HISTORIC AND DESIGN REVIEW COMMISSION

Agenda Item No: 9

HDRC CASE NO: 2015-345
ADDRESS: 321 E LOCUST
LEGAL DESCRIPTION: NCB 1738 BLK 3 LOT E 50 FT OF 5
ZONING: MF33 H
CITY COUNCIL DIST.: 1
DISTRICT: Tobin Hill Historic District
APPLICANT: Scott Carpenter/Seventh Generation Design
OWNER: Charles Turner/K/T TX Holdings, LLC
TYPE OF WORK: New construction

The applicant is requesting conceptual approval to construct a two story townhome totaling approximately 3,386 square feet. The applicant has proposed materials including Hardi Board siding, western cedar posts and rafters, insulated vinyl windows, a main roof of composition shingles, a porch roof of a standing seam metal roof and two, detached garages.

SITE PLAN

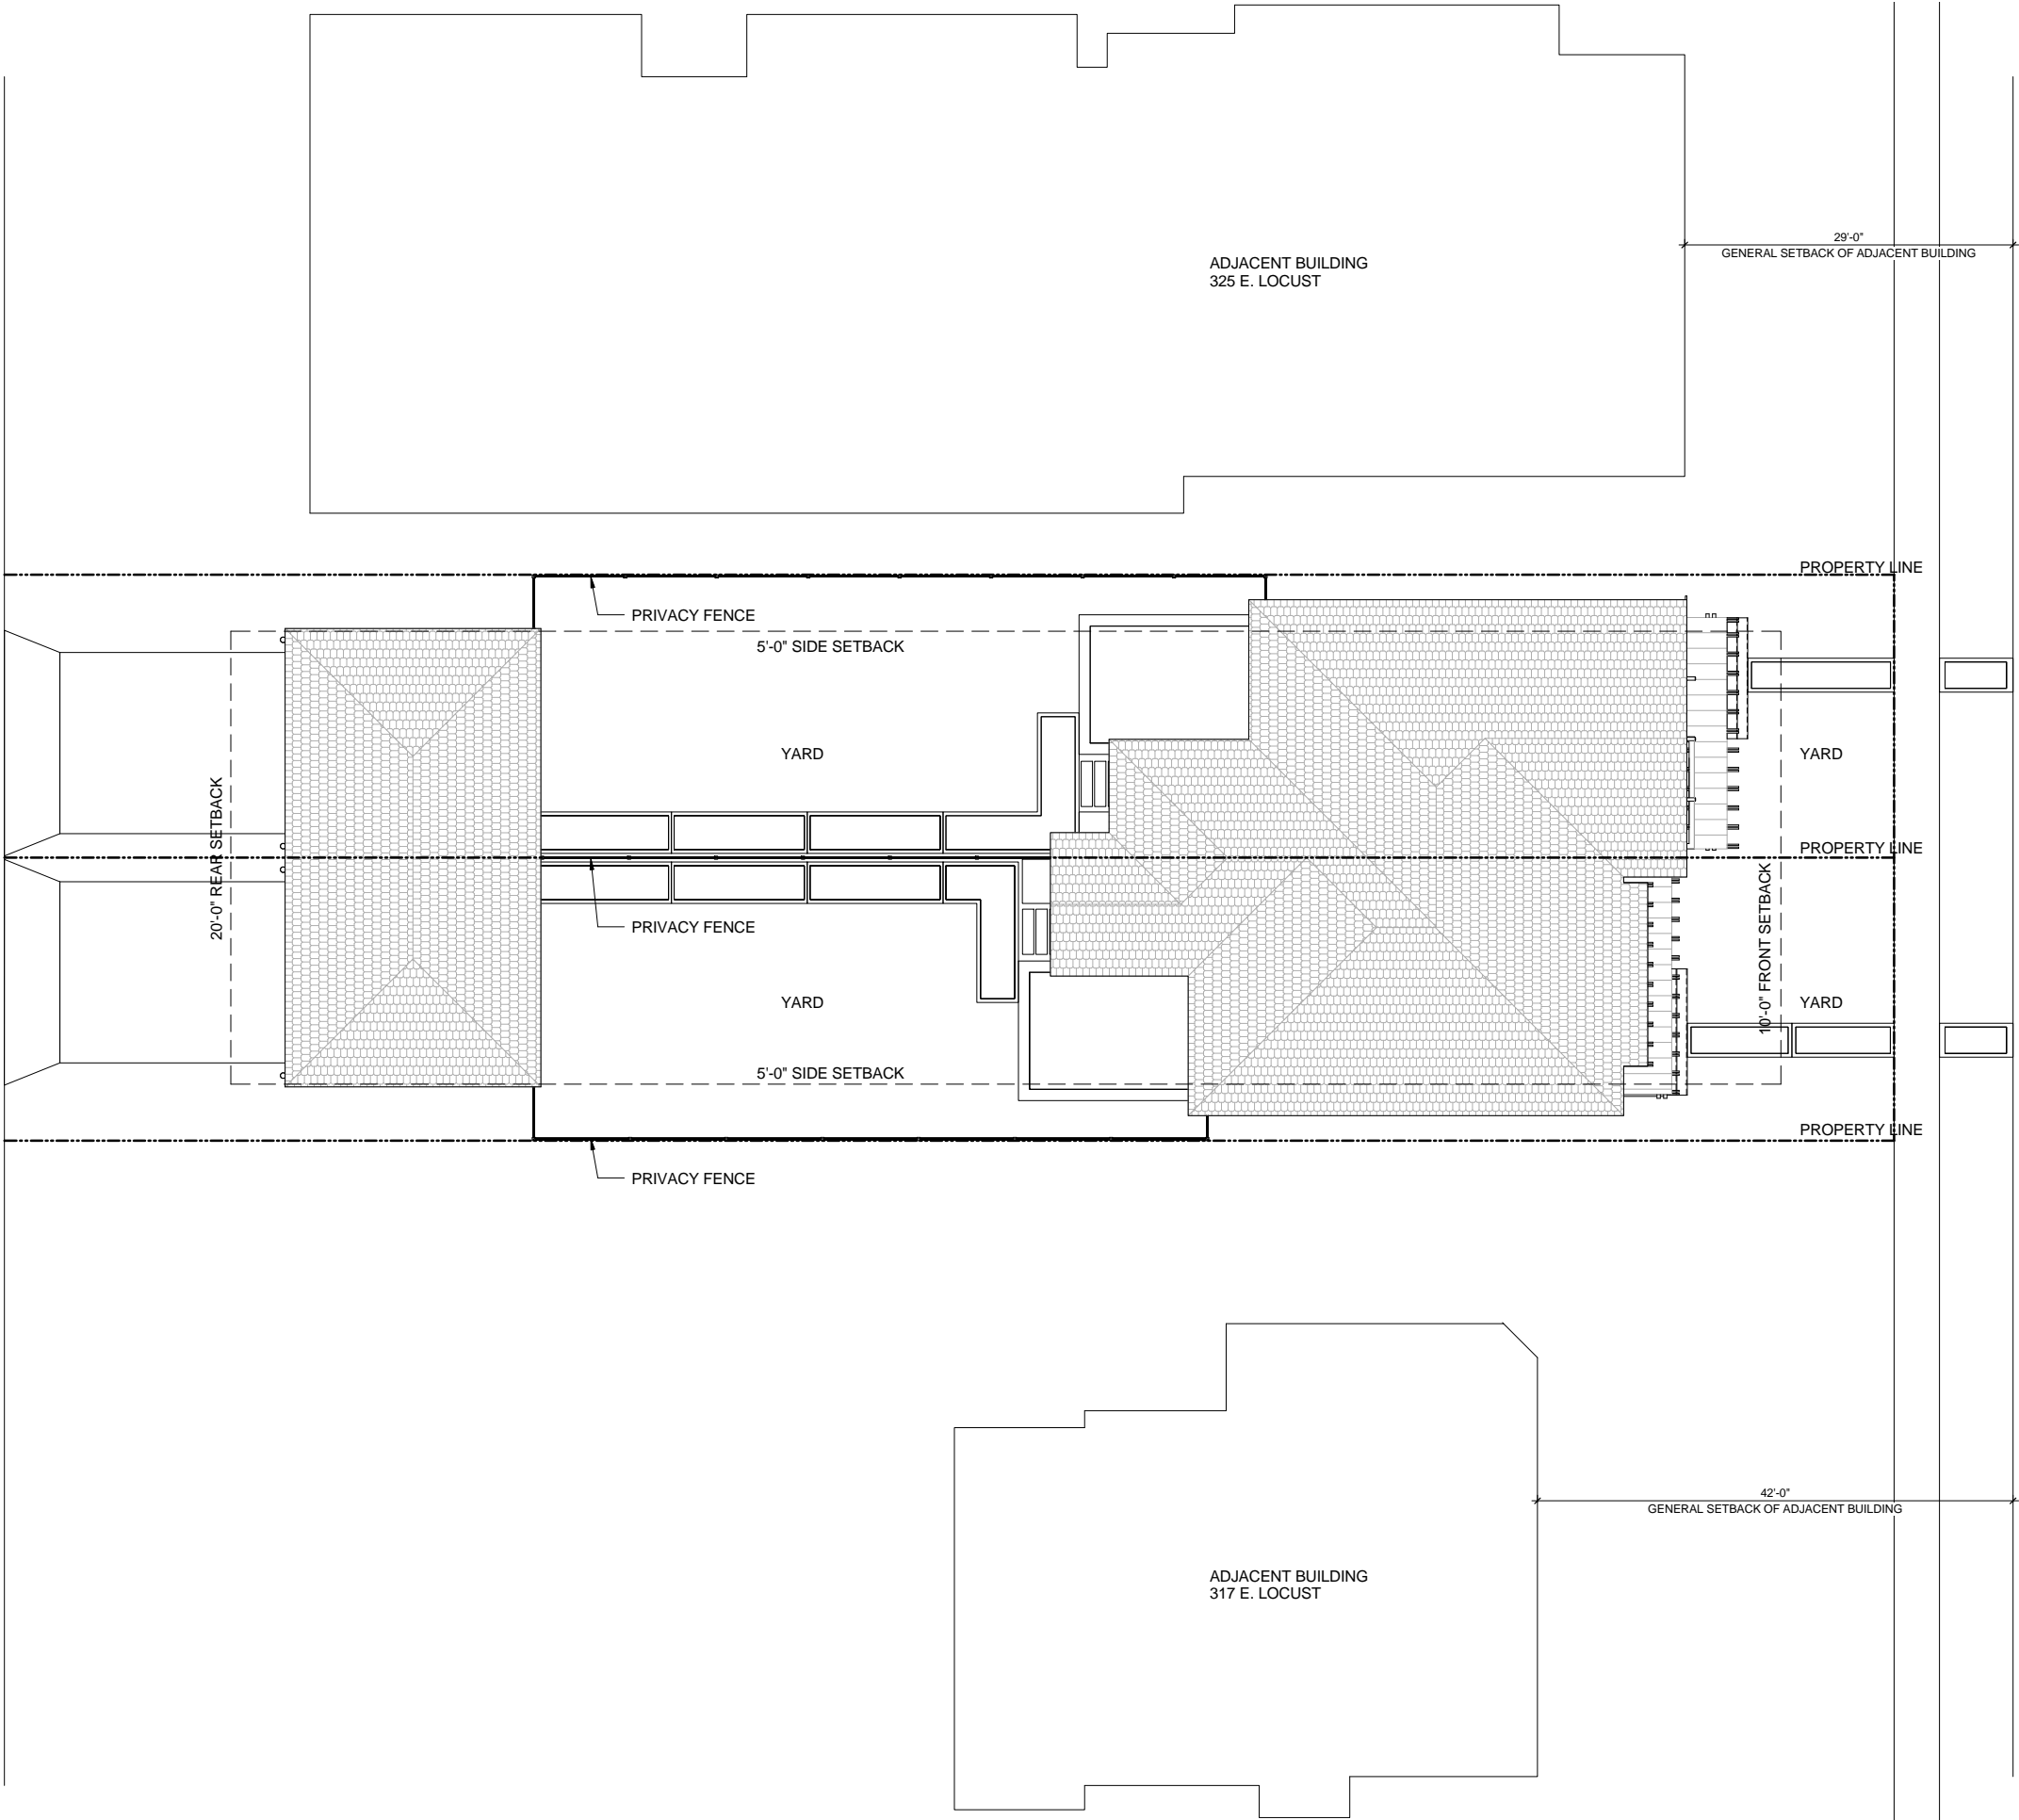
- c. The historic setback of historic homes along E Locust is approximately forty-two feet from the street. The applicant has proposed a setback of approximately twenty-nine feet to be consistent with the neighboring structure to the east, 325 E Locust. A non-contributing front addition at 325 E Locust has reduced its setback from the historic forty-two feet to the current twenty-nine feet. The applicant's proposal is not consistent with the Guidelines for New Construction 1.A.i. Staff recommends that the applicant adjust the proposed setback to be consistent with the block's historic setbacks.

- l. Mechanical equipment should be located at the rear of the property and be screened from the public right of way. The applicant has proposed a rear wood fence, however has not shown the placement of mechanical equipment on a site plan. The applicant is responsible for complying with the Guidelines for New Construction 6.A. and B.

- m. The vacant lot is currently void of existing trees except for a Crape Myrtle at the public right of way along E Locust. The applicant has noted proposed sidewalks and the front and rear yard on the provided site plan, however has not indicated any additional landscaping or hard scaping information. Staff recommends that the applicant provide a detailed landscaping plan that is separate from the provided site plan.

- p. The applicant has proposed to set back the garage approximately twenty-five feet from the rear alley. Setbacks for rear garages throughout Tobin Hill vary, however the predominant location is adjacent to the rear alley with a setback of less than five feet. Staff recommends that the applicant seek a variance to locate the proposed rear garage within the required rear setback to be consistent with the predominant setback of the district as noted in the Guidelines for New Construction 5.B.ii.

- i. That the applicant adjust the front setback to be consistent with the historic setbacks found throughout the district as noted in finding c.
- ii. That the applicant install wood windows, consistent with those found throughout the district rather than vinyl as noted in finding j.
- iii. That the applicant screen all mechanical equipment as noted in finding l.
- iv. That the applicant provide a detailing landscaping plan noting all proposed landscaping elements and materials as noted in finding m.
- v. That the applicant relocate the proposed rear garage to be consistent with the setback found historically throughout the district as noted in finding p.
- vi. That the applicant redesign the proposed garage doors to be consistent with the historic examples found throughout the district.
- vii. That the applicant address inconsistencies in front porch depth as noted in finding d.
